SERVICE BULLETIN

Dec. 28, 2015

28 Repair/Replacement For Cracked Weld On Old Style Side Output Muffler

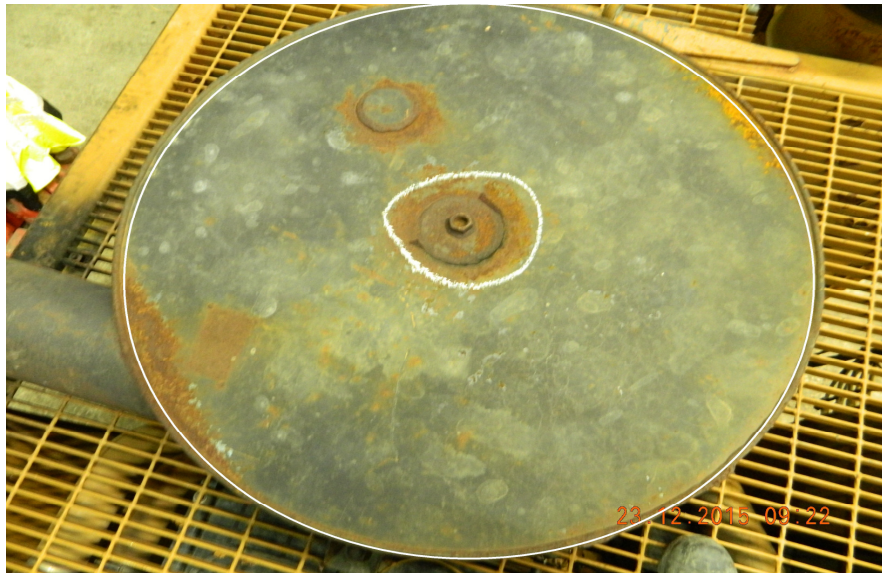
We are addressing the issue with the old style side output muffler cracking. Once the crack has started water will fill the engine and eventually cause a hydro lock in the cylinder.

We suggest checking these mufflers when they come into the yard. They can be cracked on the inside by the lifting nut, or on the outside where the large white circle is. If it is cracked it can be welded, if there is excessive damage replace it with a new style muffler.

See the below image for reference of an old style side muffler. If the mount is like the one circled in red it is the old model that will crack.
